SKILLING, HELLE, CHRISTIANSEN, ROBERTSON · Structural & Civil Engineers

PROJECT THE WORLD TRADE CENTER | TITLE KI-EL.310 REPAIR DETAIL FOR EXISTING STEEL | DATE 6-12-72

Detail F7

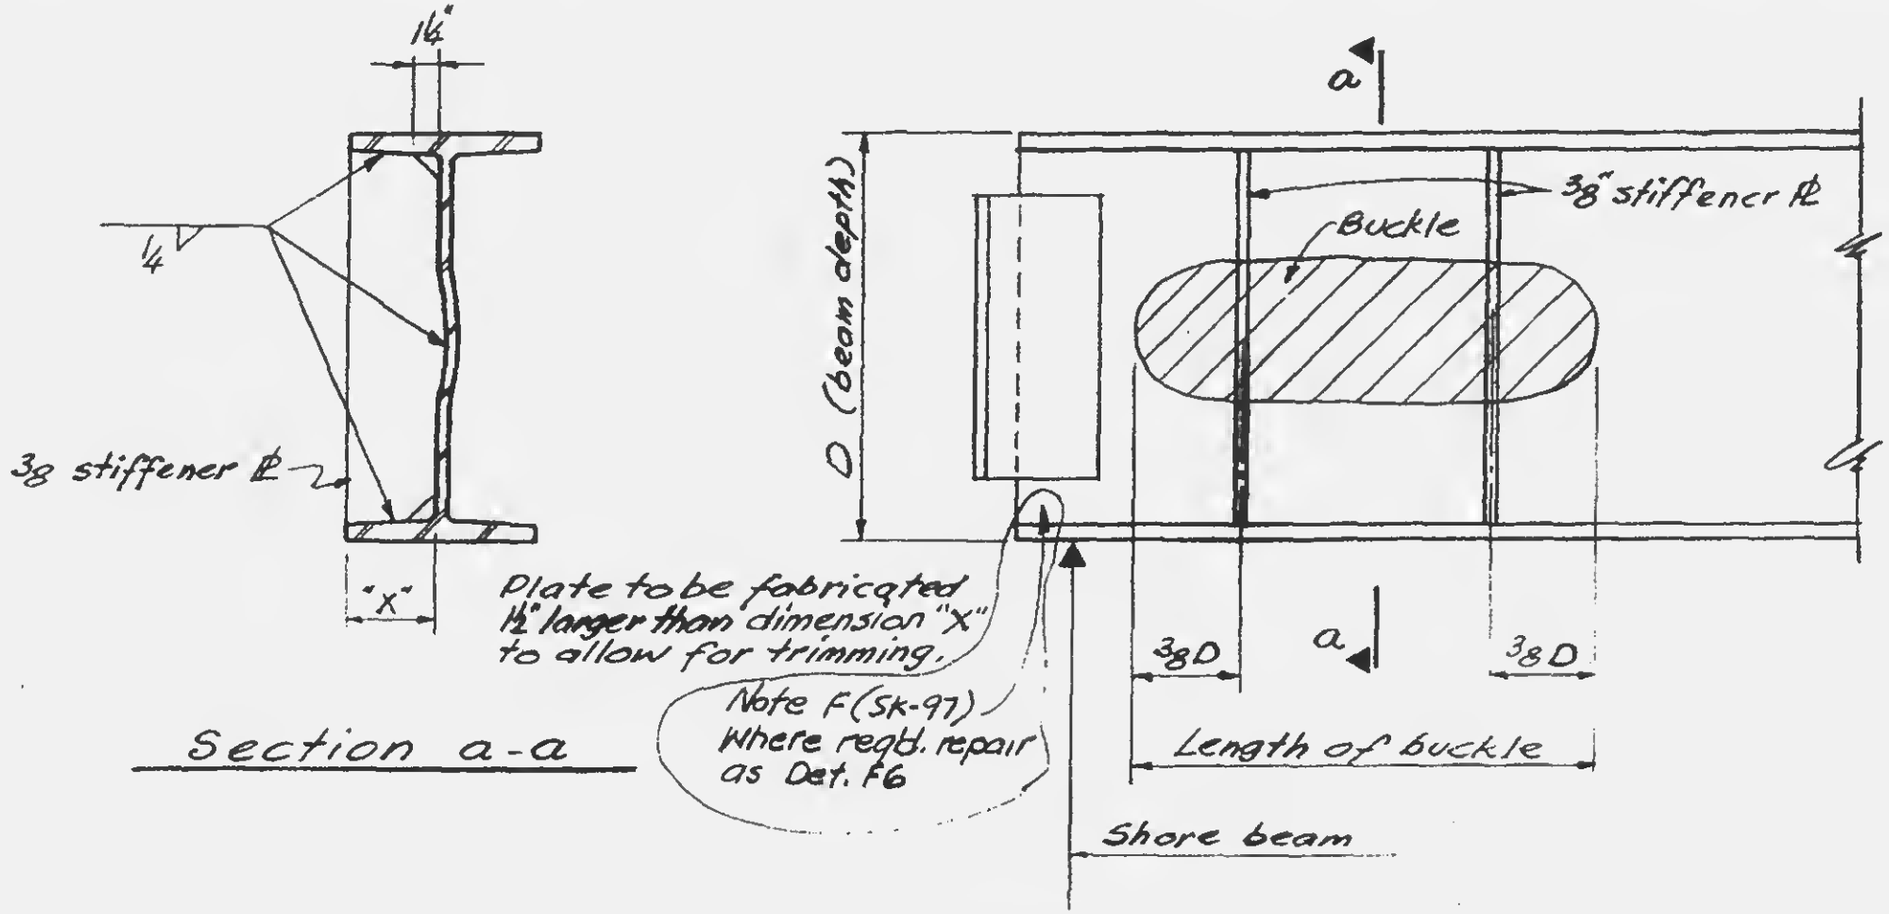
Buckled web & failed connection

3/8 stiffener plates to be placed as follows:

LENGTH OF BUCKLE	No. of PLATES	PLACEMENT OF STIFFENERS
0.75 D	1	Center in bulge
0.75 D > 1.00 D	2	as shown above
1.00 D > 2.00 D	3	2 outside as shown above - center one centered between

1. Shore beam
2. Remove damaged connection. (Bolts, angles & welds)
3. Replace with same type connection, but capacity to be as shown in Plan
4. Trim vertical stiffener plates to fit and install number and location as shown in table
5. Remove shores
